RAI 03.07.02-29, Revision 1**QUESTION:**

RAI from Section 3.7 Audit, October 2010

REVISED RESPONSE:

**Figure 03.07.02-29.48: Comparison of Spectra – Roof Slab
Z Direction**

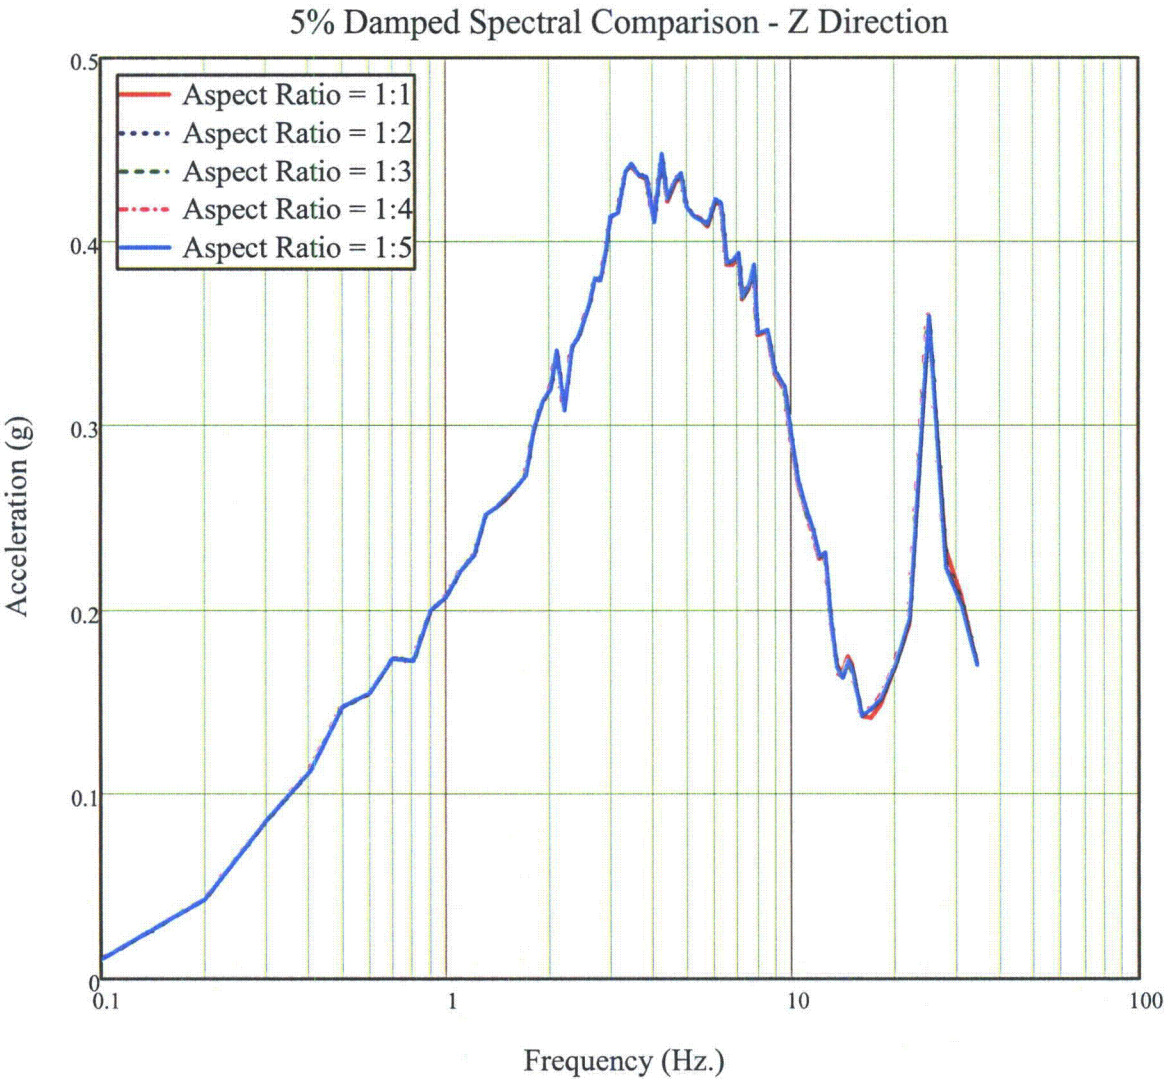
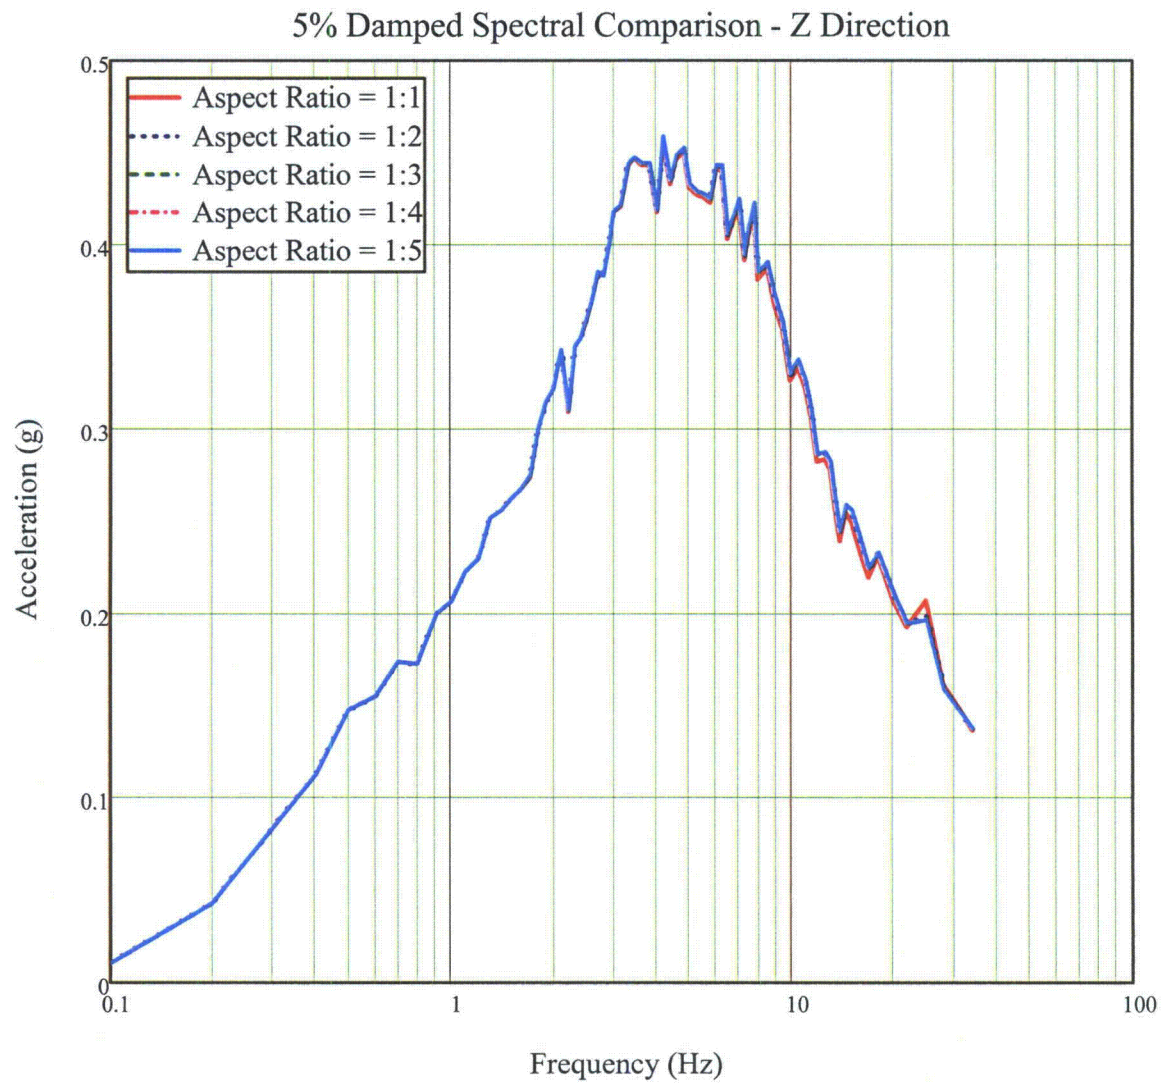
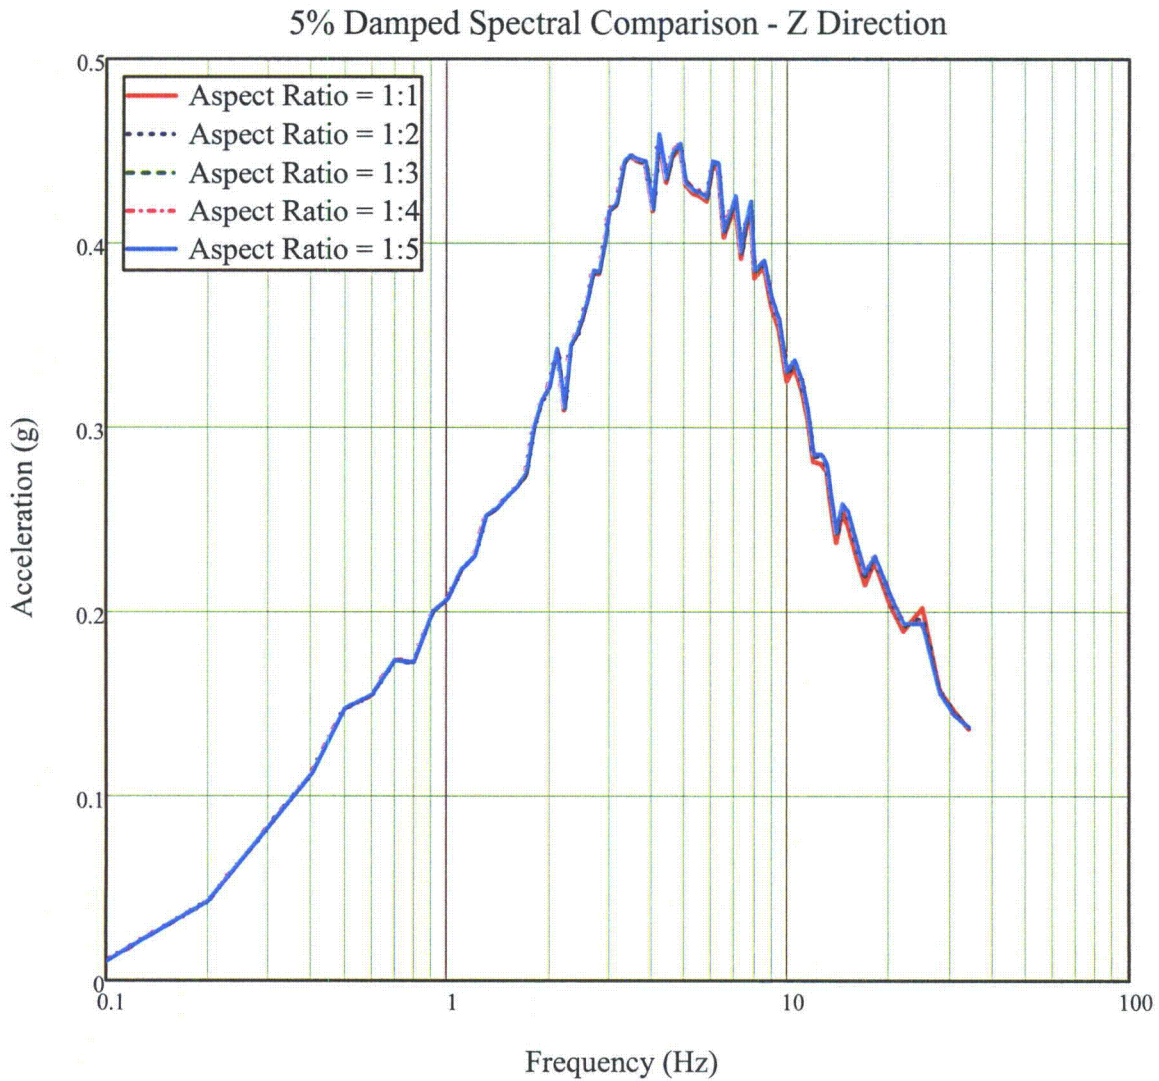
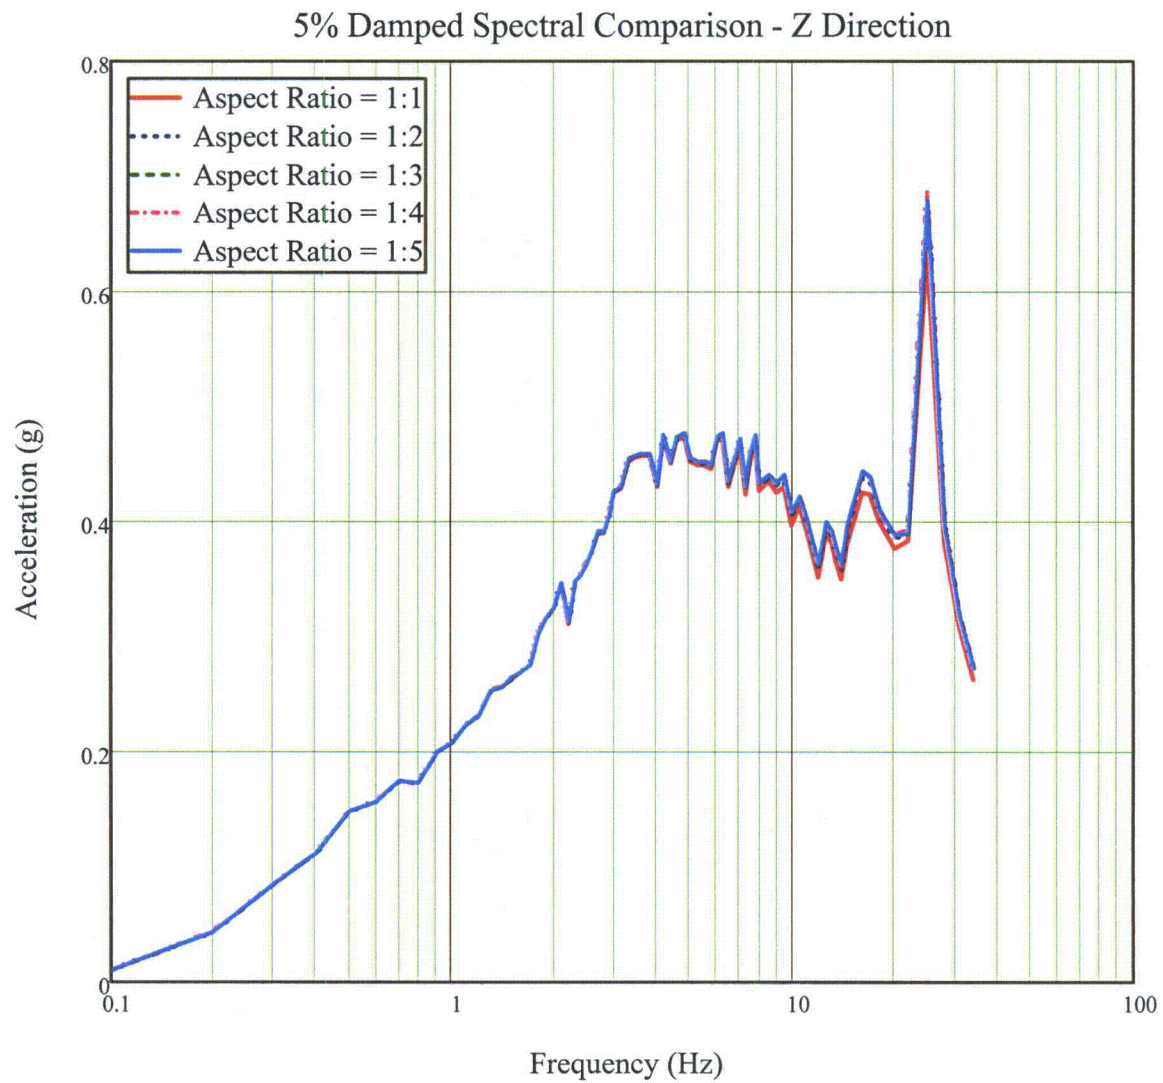
- **Acceptable aspect ratio of rectangular elements (solid, shell and plane-strain) to obtain accurate results, as used in the models**

Figures 03.07.02-29.45 through 03.07.02-29.48 show the comparisons of Z direction 5% damped in-structure response spectra, due to the Z direction excitation, for various aspect ratios models. The comparisons show that the response spectra compare well for aspect

ratios up to 1:5, for all locations except at the top of roof slab (Figure 03.07.02-29.48). At the top of the structure, the peak of the response spectra for models with the aspect ratios 1:2 to 1:5 are 7% - 9% higher than the 1:1 aspect ratio model. This exceedance is within 10% and also conservative compared to the 1:1 aspect ratio model.
